ADDENDUM #2

PROJECT: Thousand Islands Secondary School
HVAC Replacement & Upgrades
PROJ. NO.: 24078
DATE: April 29, 2026

ND
i01

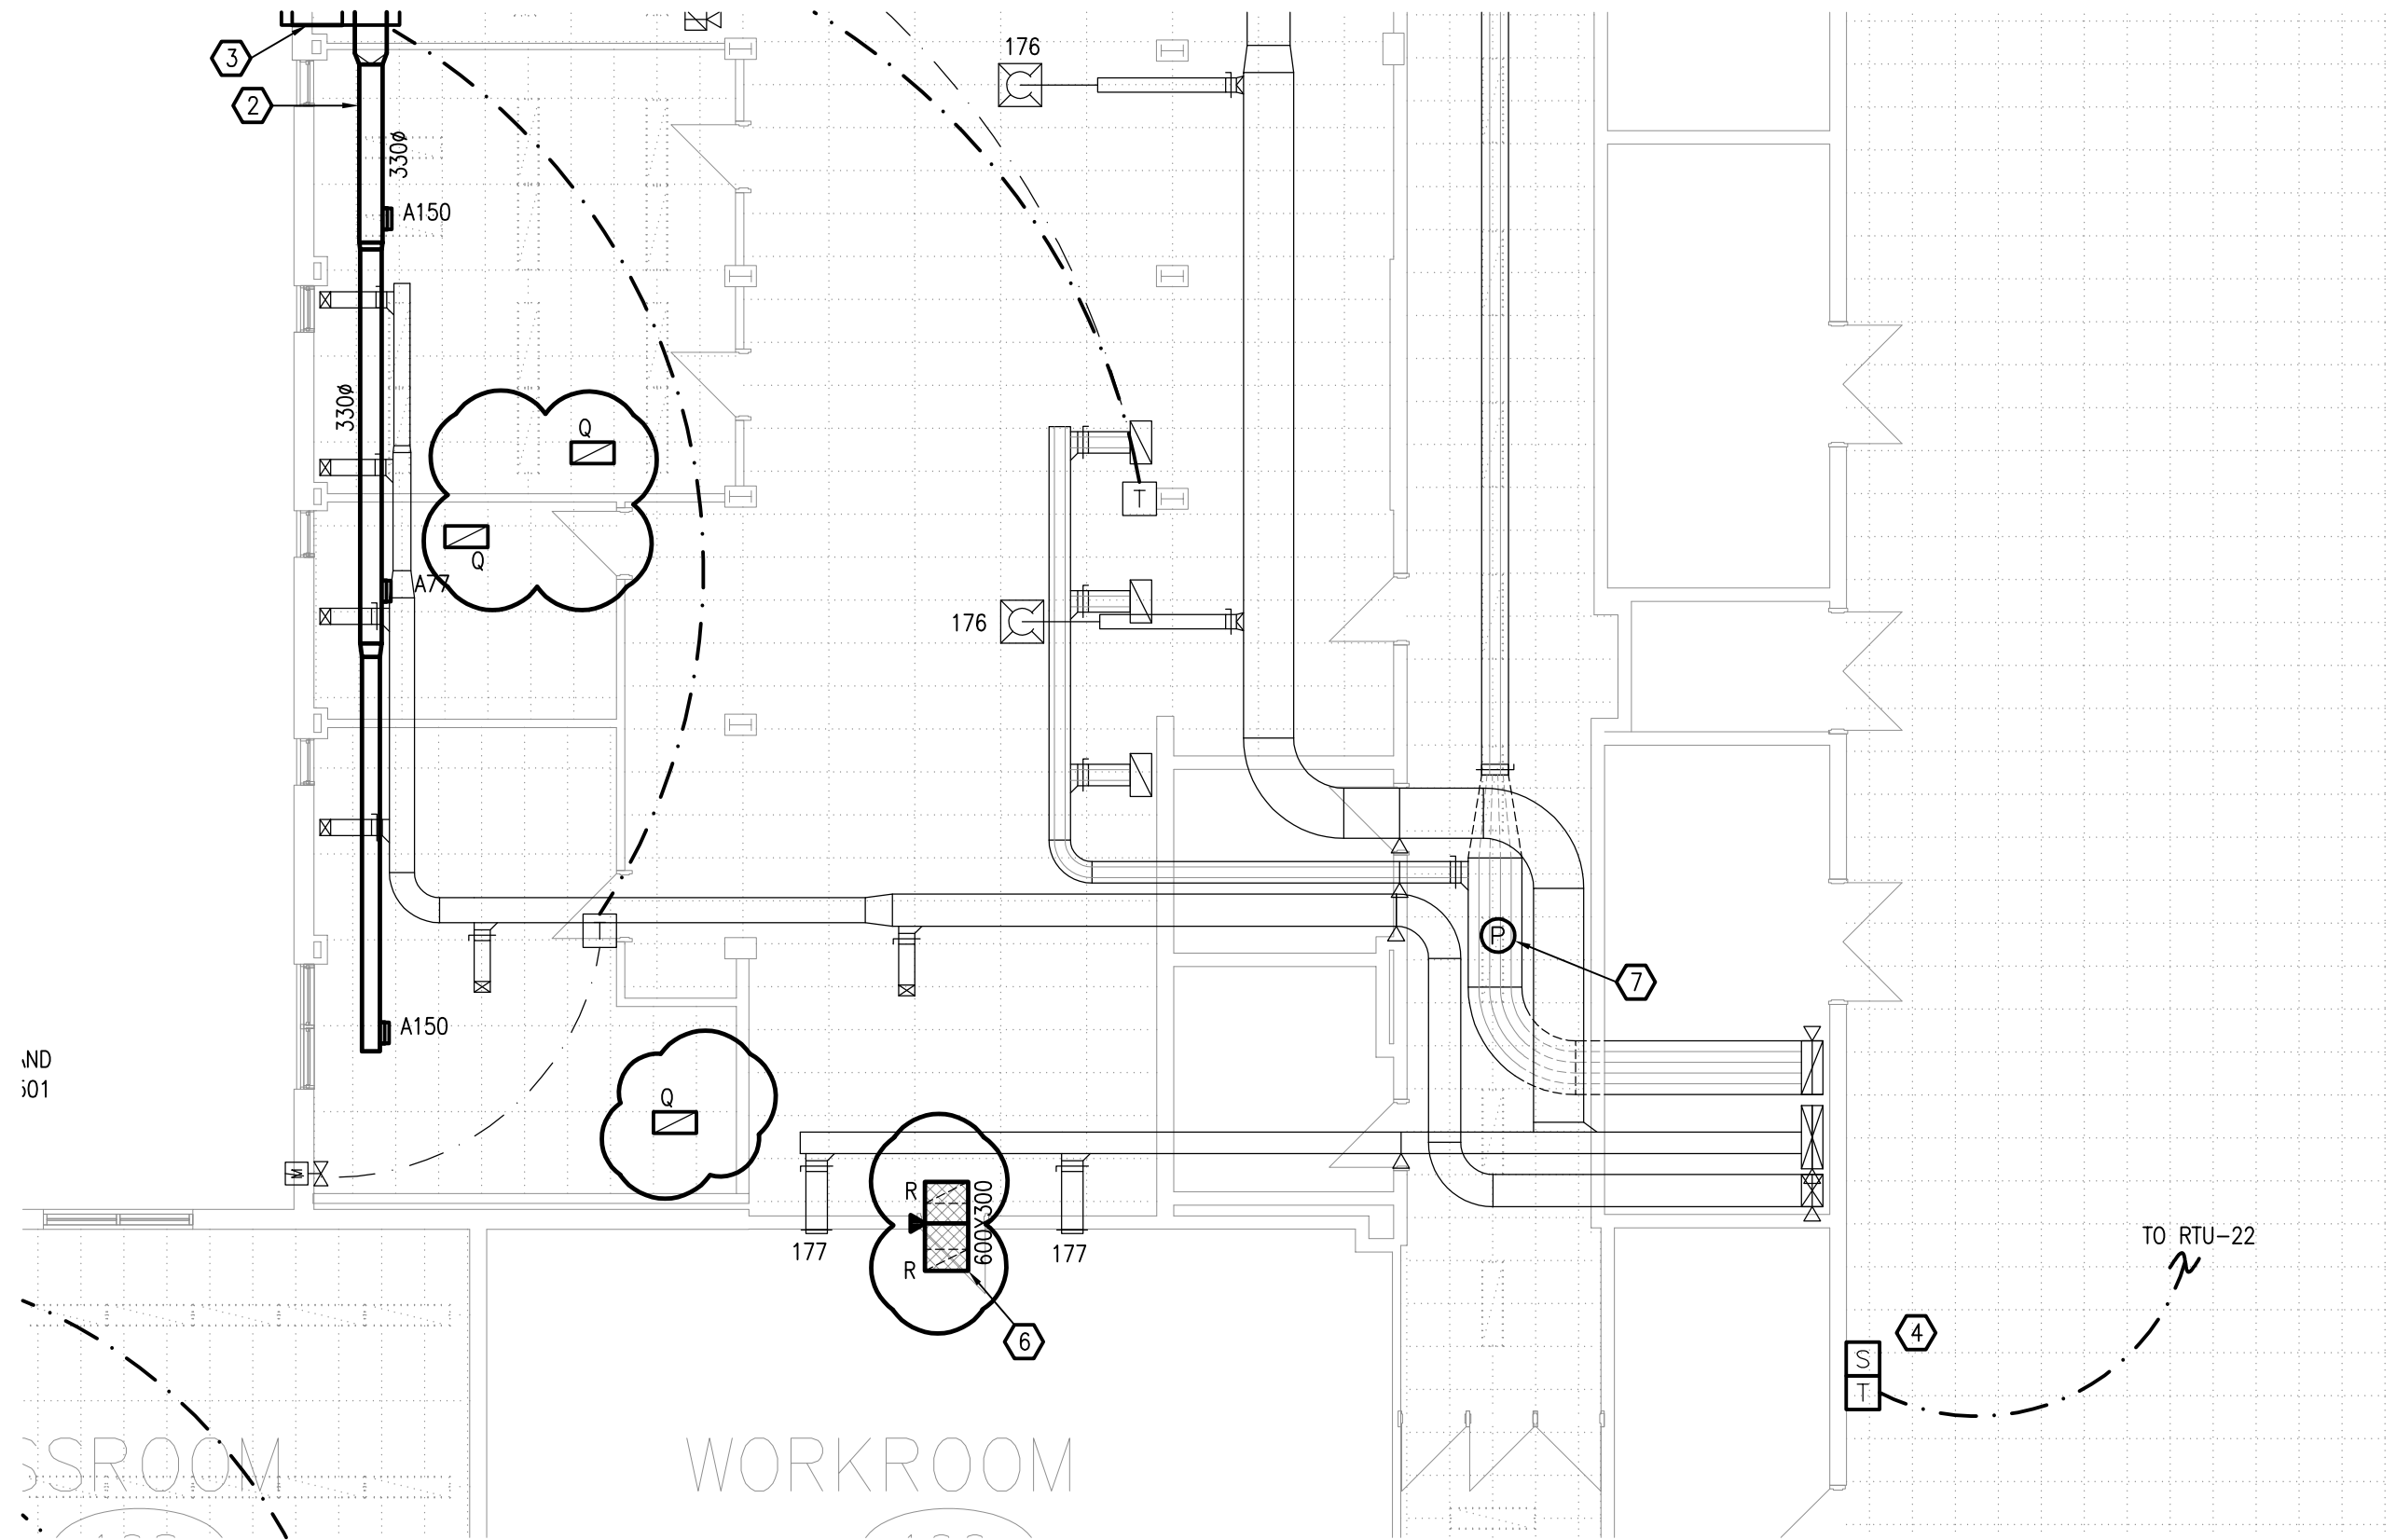
- .4 Revise design as per attached sketches SKM-ADDM002A to SKM-ADDM002E.

- ① CUT BACK AND REMOVE DUCTWORK AS INDICATED. CAP DUCT ON CORRIDOR SIDE AND CLOSE FIRE DAMPER. WALL GRILLES TO REMAIN.
- ② CUT BACK DUCTWORK AS INDICATED AND CLOSE FIRE DAMPER AT SECOND FLOOR SLAB AND CAP DUCTWORK BELOW SECOND FLOOR SLAB. ABANDON DUCTWORK WITHIN SHAFT.

CONDENSING UNIT - SEISMIC INSTALLATION DETAILS
SCALE:- 1:15

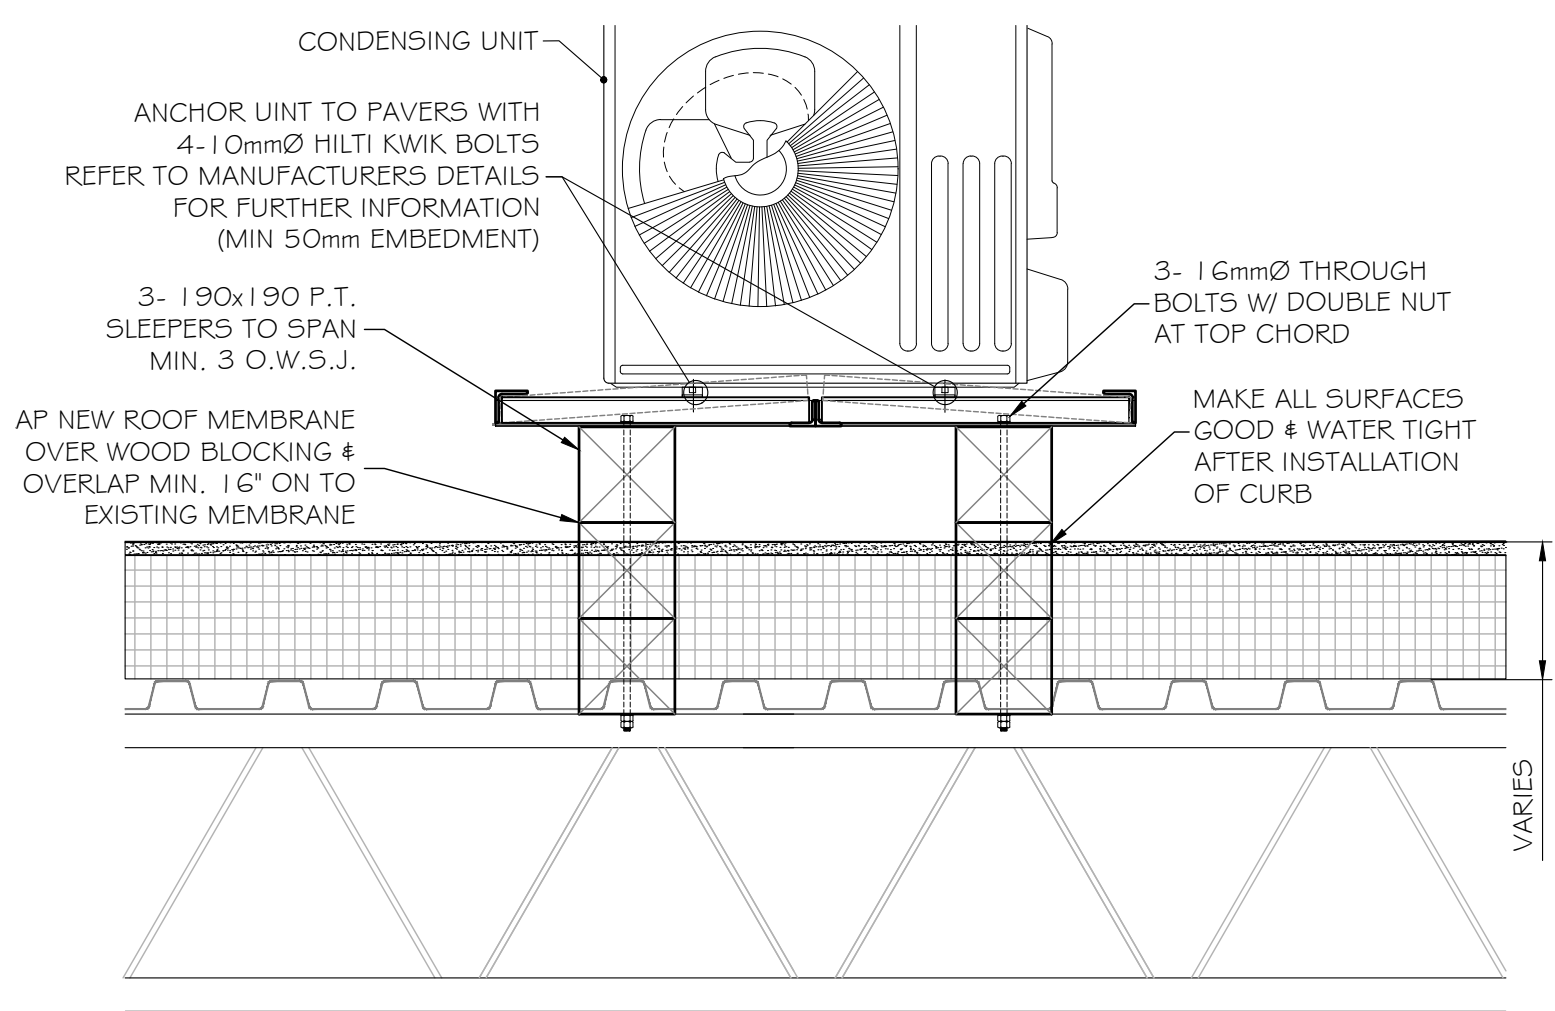
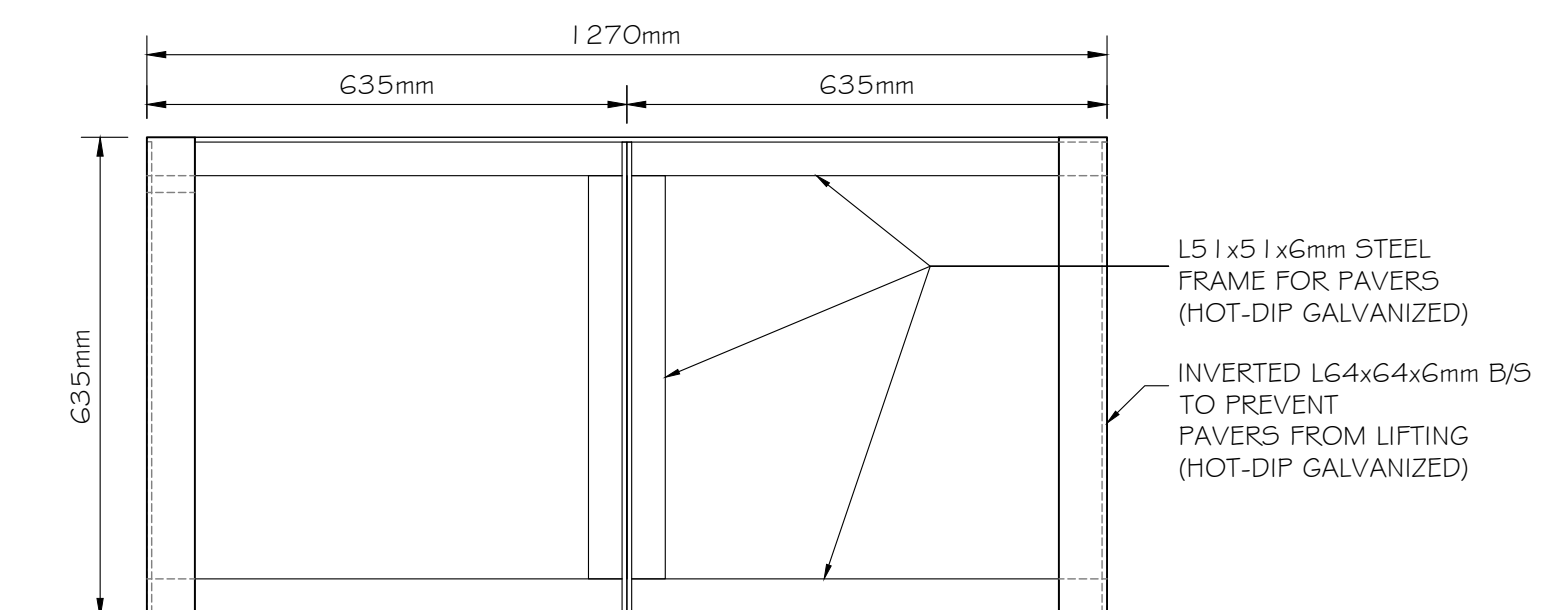
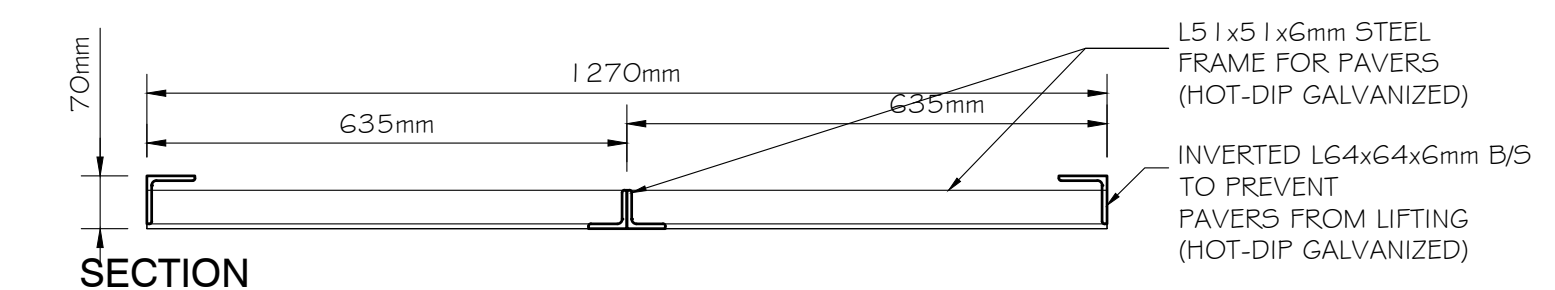
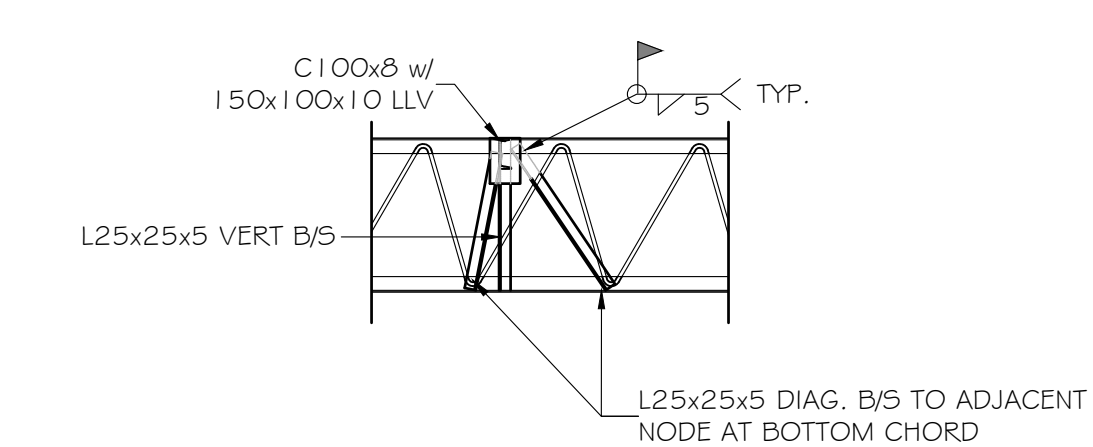
3. Q: Detail 7/4 on Roofing Drawing 4 shows a built-up wood sleeper for Air Condenser Unit, detail states see structural for wood dimension and connection to building. Structural drawings have no built-up wood detail, instead a different detail using a steel frame and pavers. Please clarify which detail is to be used. If built-up wood please provide details with materials, sizes and how it is to be fastened to structure.

A: The condenser units to be installed on wood sleepers per the roofing details. Refer to revised condensing unit detail on structural drawing S2.
